## CCPS RFP#25-04 – NORTH EAST MIDDLE/HIGH SCHOOL REPLACEMENT PROJECT

### ADDENDUM #7

**This addendum is to provide the pre-bid agenda and attendance list and issued revisions to the contract documents as noted below.** Proposers and related parties will be responsible for reading and understanding all documents, the scope of work, addenda and all related solicitation documents issued. These documents will become attached to and part of the solicitation and award of bid contract.

1. **ASIs 01 and 02**
2. **PR 01**
3. **CLOSED RFIs 001- 0027, 029-031, 034. (open RFIs are excluded)**

E8 TYP. FOUNDATION DETAIL W. METAL STUD BACK-UP  
1' 4 1/2" = 4' 0"

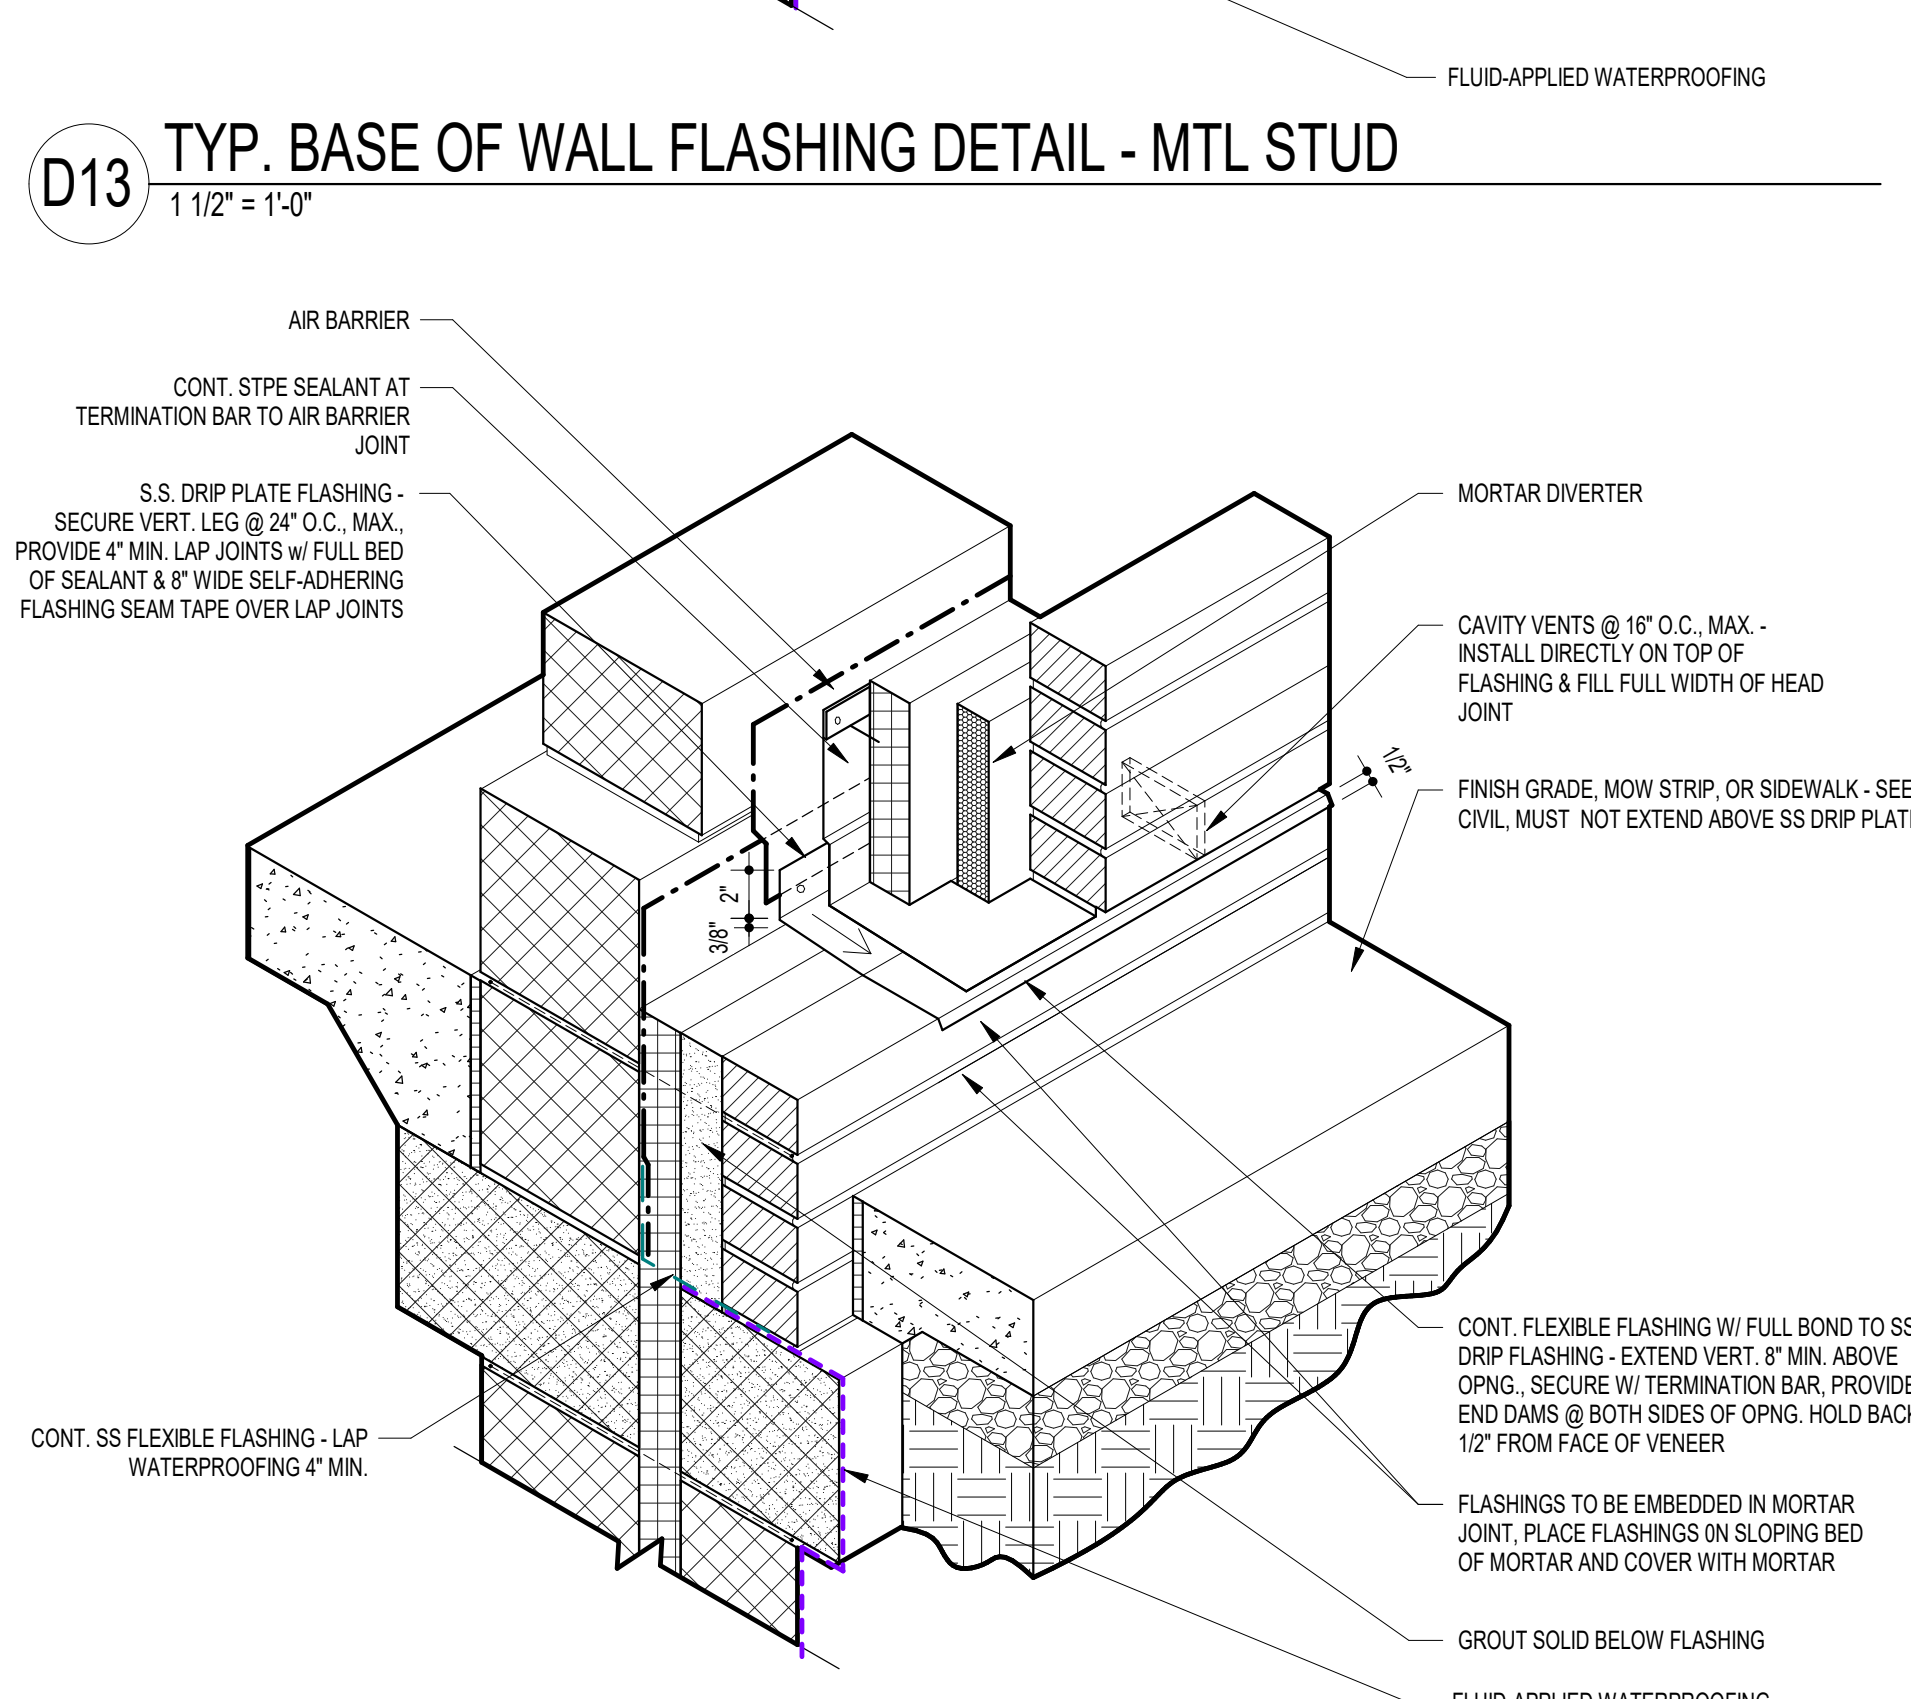
Activities	By	At
Joshua, Detail A7/A427 shows the waterproofing extending on the horizontal surface of the footing. See below. Thanks, Patrick	Patrick Byrne	Jul 8, 2024, 2:48 PM EDT
<b>Joshua Postadan</b> changed the status from  <b>Closed</b> to  <b>Open</b> Answered set Ball in court to <b>Joshua Postadan</b> (HESS Construction Co., LLC) changed the <b>ID</b> to <b>009.1</b>	Joshua Postadan	Jul 8, 2024, 2:37 PM EDT
Patrick, 07 11 13 Section 3.3 B calls for the dampproofing to extend over top of footing and down a minimum of 6 inches, whereas Detail A7/A427 shows the dampproofing terminating at the top of footing. Please advise whether the dampproofing should be applied per the detail or the specification and please revise the detail/specification accordingly.	Joshua Postadan	Jul 8, 2024, 2:37 PM EDT
<b>Joshua Postadan</b> changed the status from  <b>Open</b> Answered to  <b>Closed</b> <b>Official response:</b> Patrick Byrne (Grimm and Parker): See attached RFI response. set Ball in court to <b>Glenn Feldstein</b> (George Moehrle Masonry)	Joshua Postadan	Jul 8, 2024, 9:57 AM EDT

Install the waterproofing as shown on the detail A7/A427 on the outer wythe of the CMU wall.

**S102F**  
12/22/2023  
BID SET

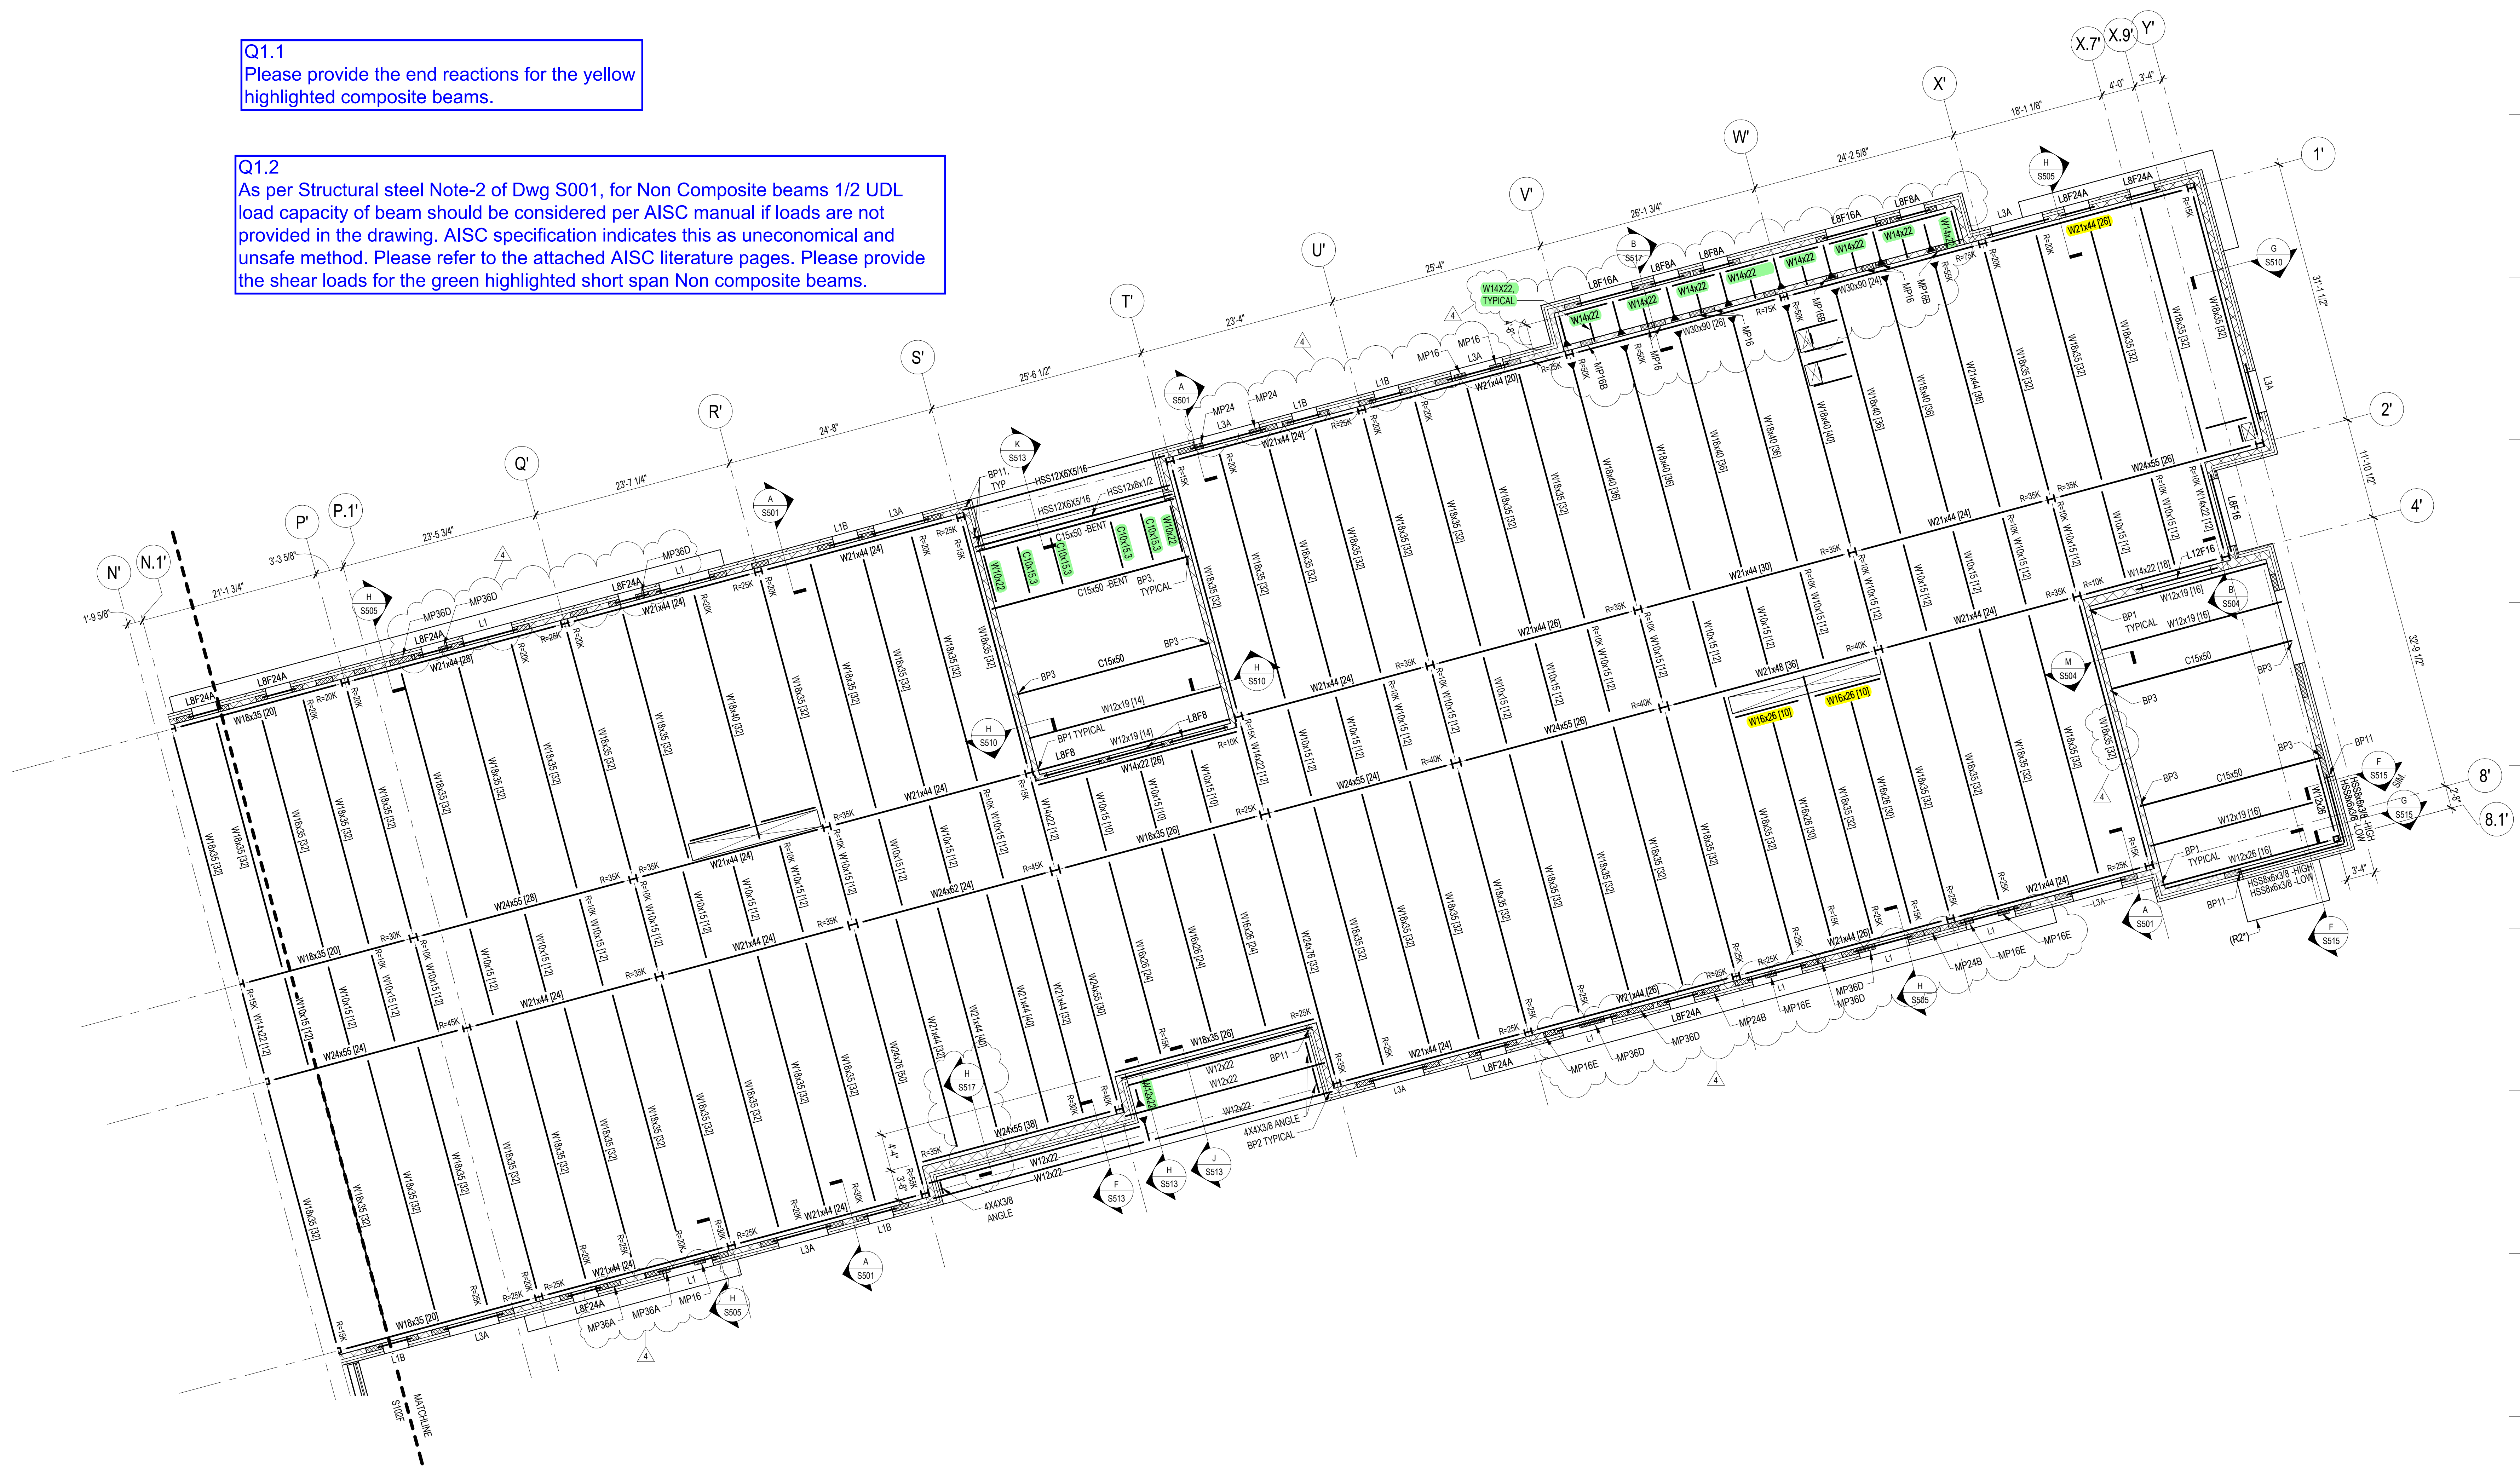
Q1.2  
As per Structural steel Note-2 of Dwg S001, for Non Composite beams 1/2 UDL load capacity of beam should be considered per AISC manual if loads are not provided in the drawing. AISC specification indicates this as uneconomical and unsafe method. Please refer to the attached AISC literature pages. Please provide the shear loads for the green highlighted short span Non composite beams.

**PENTHOUSE FLOOR AND ROOF FRAMING PLAN AREA G**  
SCALE: 1/8" = 1'-0"

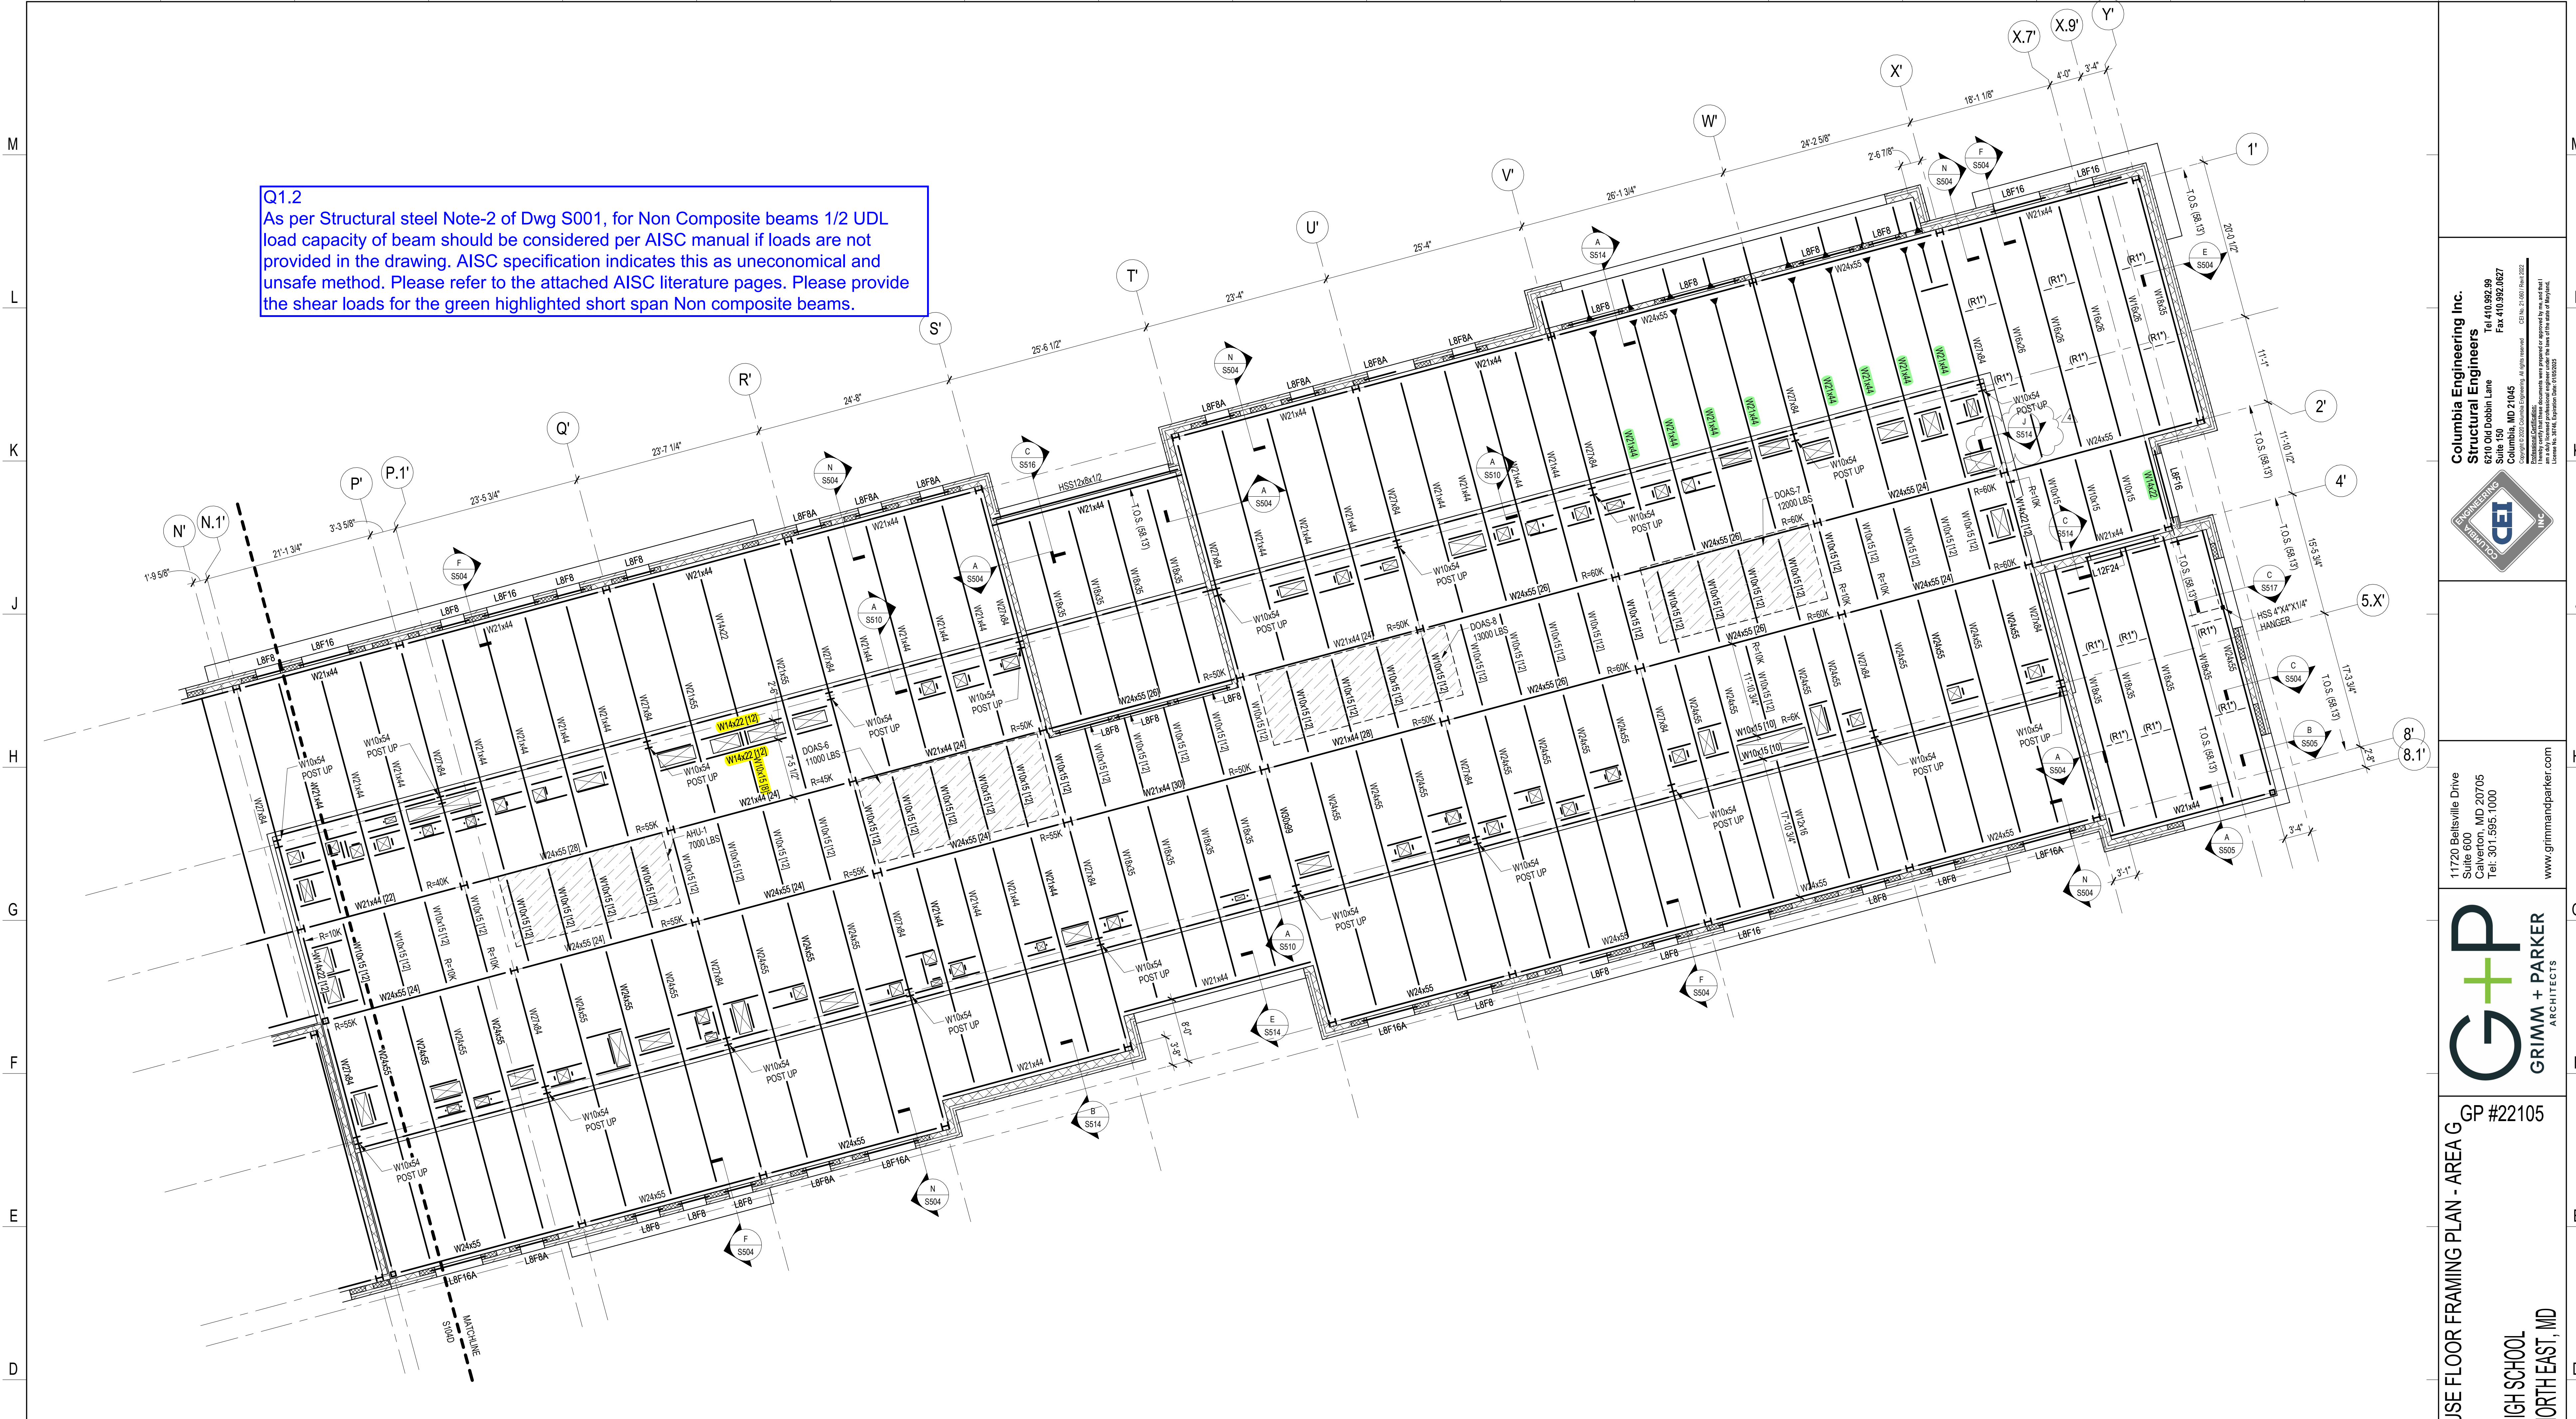
**Q1.2**  
As per Structural steel Note-2 of Dwg S001, for Non Composite beams 1/2 UDL load capacity of beam should be considered per AISC manual if loads are not provided in the drawing. AISC specification indicates this as uneconomical and unsafe method. Please refer to the attached AISC literature pages. Please provide the shear loads for the green highlighted short span Non composite beams.
